Access Compliance Report

Public Rights-of-Way

(Curb Ramps)

Intersection ID: 48001	Main Street: LARKMEAD_FOREST_DR	Cross Street: CLYMER_CT	Location:	NW
ADA ID: 682C65318CEA	Ramp Type: Perp	Initial Pass/Fail: Fail	Overall Compliance: No	Severity Score: 22.5

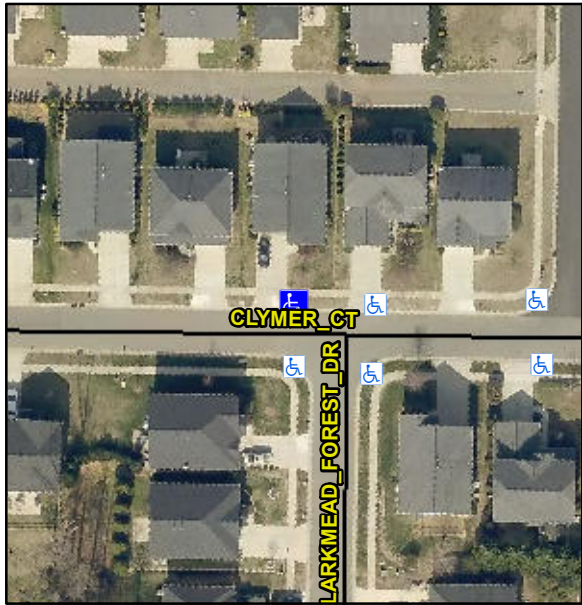
Codes/Mitigation Info/Possible Solution			Field Measurements/Component Compliance					
	Possible Solutions:		Remove & Replace Entire Ramp.					
	Surveyor Notes:		N/A					
	PROW/ADA:		Not Found, R304.5.1, R304.2.2, R304.5.3					
	Total Cost:		\$ 1850.00					
	Street 1 Name		CLYMER CT					
	Stop Condition-Street 2		None					
	Street 2 Name		N/A					
	Stop Condition-Street 1		N/A					
			Compliance	Description	Data	Compliance	Description	Data
			N/A	Ramp Length (in)	71.5	No	Ramp Slope (%)	9.8
			No	Ramp Width (in)	46.0	No	Ramp XSlope (%)	3.1
			N/A	Flare Type LT	N/A	N/A	Flare Type RT	N/A
			N/A	Flare Slope LT (%)	N/A	N/A	Flare Slope RT (%)	N/A
			N/A	Flare Traversable LT?	N/A	N/A	Flare Traversable RT?	N/A
			N/A	Landing Length (in)	N/A	N/A	DWS Provided?	N/A
			N/A	Landing Width (in)	N/A	N/A	DWS Contrast?	N/A
			N/A	Landing Slope (%)	N/A	N/A	DWS Length (in)	N/A
			N/A	Landing X Slope (%)	N/A	N/A	DWS Full Width?	N/A
